Directive de Navigabilité de l'EASA de référence 2023-0193

Ballons à air chaud - Ensemble brûleur et crochet - Inspection / Modification

AD No.: 2023-0193

FB6 Double Burner Assembly

Figure 1 – Affected Part

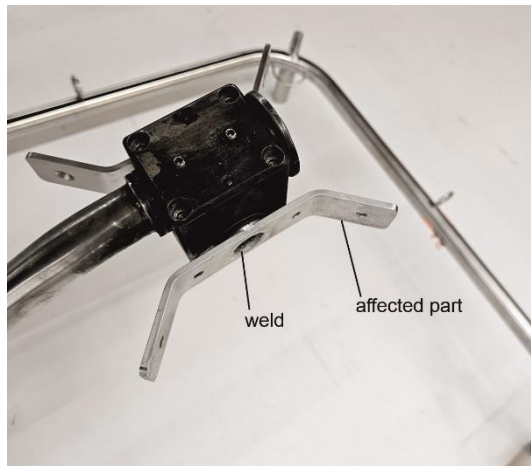
Affected part: Connector of FB6 double burner hanger, except a serviceable part. See Appendix 1 to this AD.

An occurrence was reported of a burner type FB6 S/N 2.1239-1 where the connector between the burners was found detached during transportation, leaving one burner unit detached from the load frame. Investigation revealed that the welding process may have been improperly done, due to an insufficiently detailed description of that process in production. The suspected direct cause of failure is fatigue cracking of the weld, mainly due to improper handling during transportation.

- (1) Within 12 months or 100 flight hours (FH), whichever occurs first after the effective date of this AD, accomplish an inspection of the weld of each affected part, installed on a balloon, in accordance with the instructions of the TN.

- (2) If, during the inspection as required by paragraph (1) of this AD, any crack is detected or evidence of a weld with insufficient filler material is found, before next flight, replace the affected part with a serviceable part, in accordance with the instructions of the TN.

- (3) If, during the inspection as required by paragraph (1) of this AD, sufficient filler material, as defined in the TN, is found on an affected part, before next flight, mark that part in accordance with the instructions of the TN.

Figure 1 –
Pièce
affectée

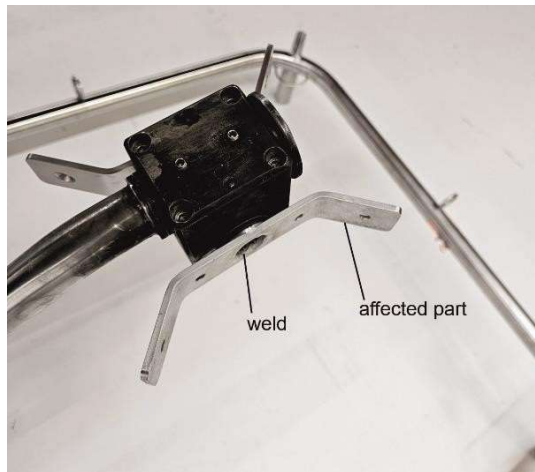
Pièce affectée : Connecteur de la suspension du double brûleur FB6, à l'exception d'une pièce en bon état. Voir l'annexe 1 de la présente CN.

Un brûleur de type FB6 S/N 2.1239-1 a fait l'objet d'un rapport dans lequel le connecteur entre les brûleurs s'est détaché pendant le transport, laissant un brûleur détaché du cadre de charge. L'enquête a révélé que le processus de soudage pourrait avoir été mal effectué, en raison d'une description insuffisamment détaillée de ce processus dans la production. La cause directe présumée de la défaillance est la fissuration par fatigue de la soudure, principalement due à une mauvaise manipulation pendant le transport.

- (1) Dans les 12 mois ou 100 heures de vol (FH), selon ce qui se produit en premier après la date d'entrée en vigueur de la présente CN, effectuer une inspection de la soudure de chaque pièce concernée, installée sur un ballon, conformément aux instructions de la TN.

- (2) Si, au cours de l'inspection prévue au paragraphe 1 de la présente CN, une fissure est détectée ou des signes d'une soudure avec un matériau d'apport insuffisant sont découverts, avant le vol suivant, remplacer la pièce affectée par une pièce en état, conformément aux instructions de la TN.

- (3) Si, au cours de l'inspection requise par le paragraphe (1) de la présente CN, une quantité suffisante de matériau d'apport, telle que définie dans la TN, est trouvée sur une pièce affectée, avant le prochain vol, marquer cette pièce conformément aux instructions de la TN.
